Submissions Report

Snowy 2.0 Transmission Connection Project
(March 2022)

Figure 3-4 Overview of the amended project

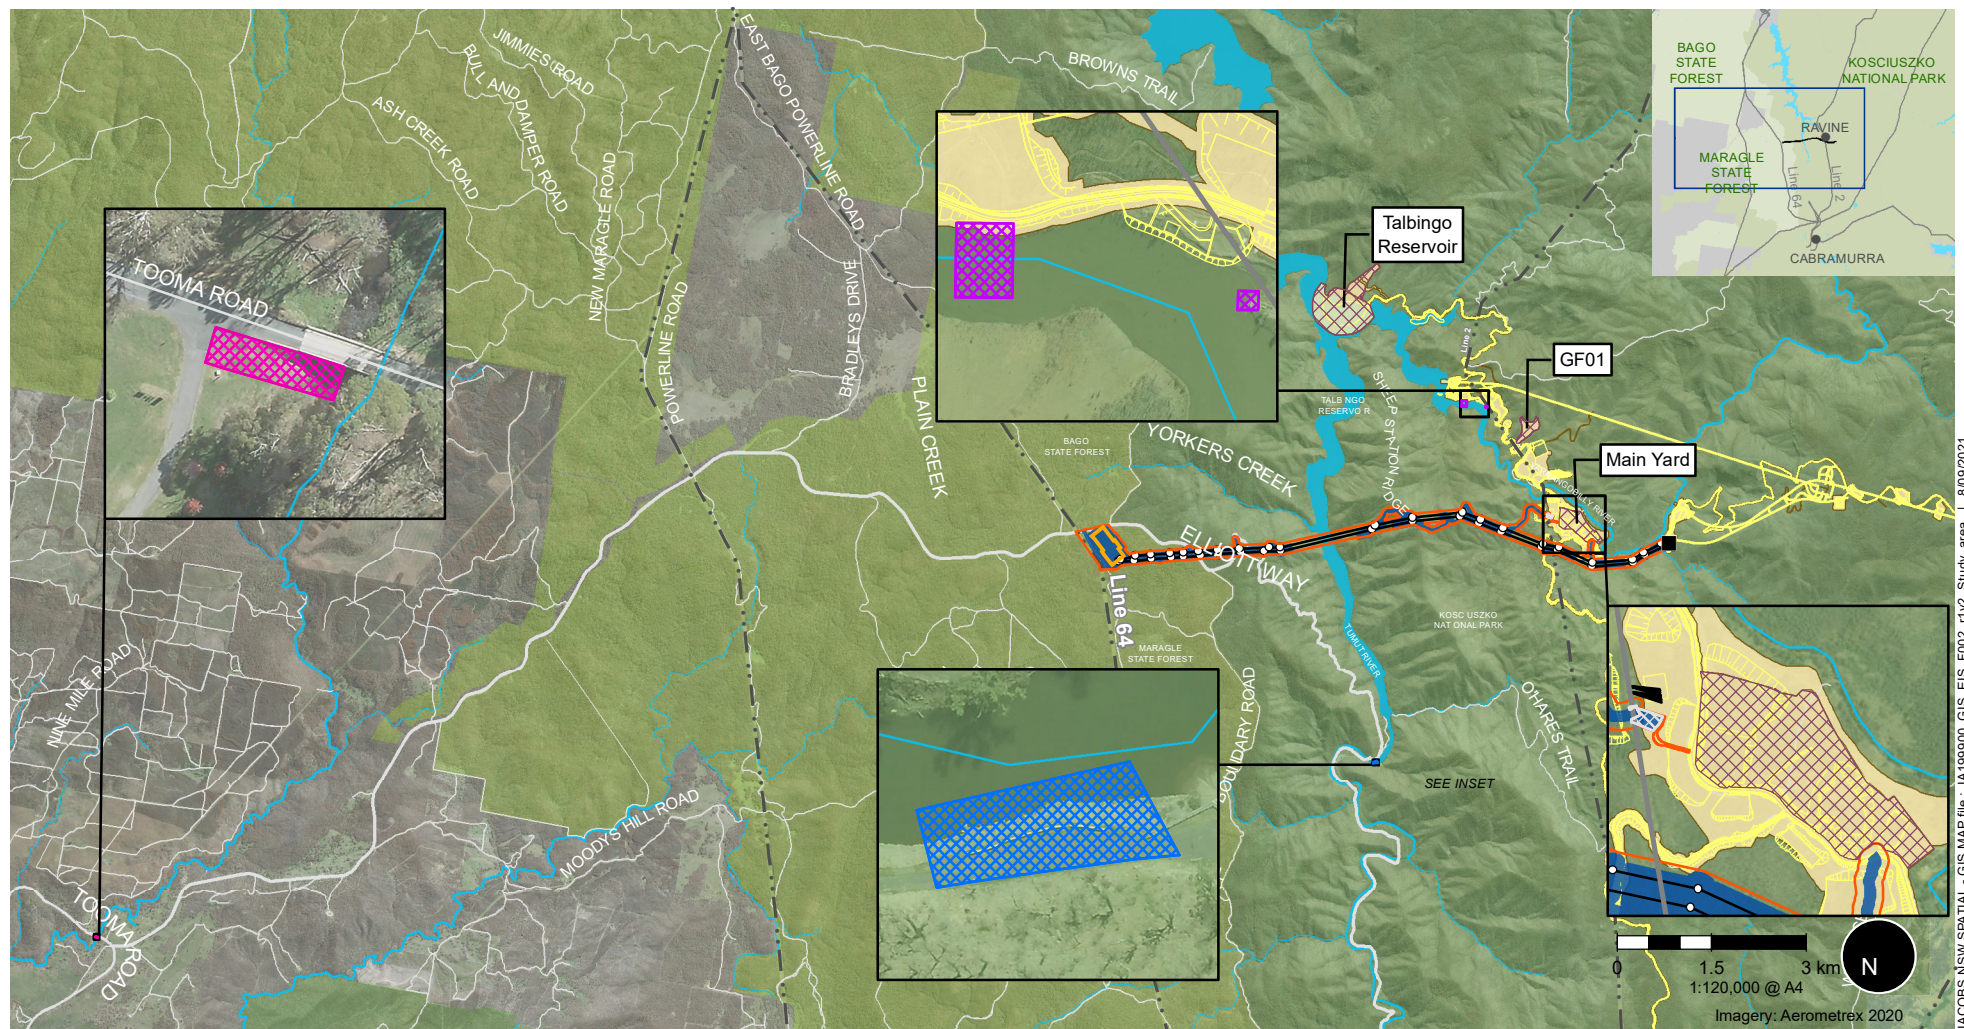
Following exhibition of the EIS, and in response to the issues raised in submissions, Transgrid identified amendments to the project as presented in the EIS. These amendments provide functional improvements to the design, confirm elements of the project that were highlighted as opportunities in the EIS, and take into account ongoing development of the construction methodology.

- A reduction to the disturbance area from approximately 143 hectares (ha) to approximately 125 hectares
- The inclusion of six distinct management zones within the reduced disturbance area
- Access track amendments including the introduction of an additional track and the realignment of another track in project area east to align with the equipment storage and laydown area adjacent to Transgrid's Ravine substation
- Increased substation footprint to accommodate a wider asset protection zone to meet compliance with *AS5339-2018 Construction of buildings in bushfire prone areas*
- Alternative spoil disposal within the approved Snowy 2.0 Main Works footprint to accommodate the disposal of spoil generated in project area east
- New water uptake sites to facilitate construction in project area west
- Removal of the helipad.
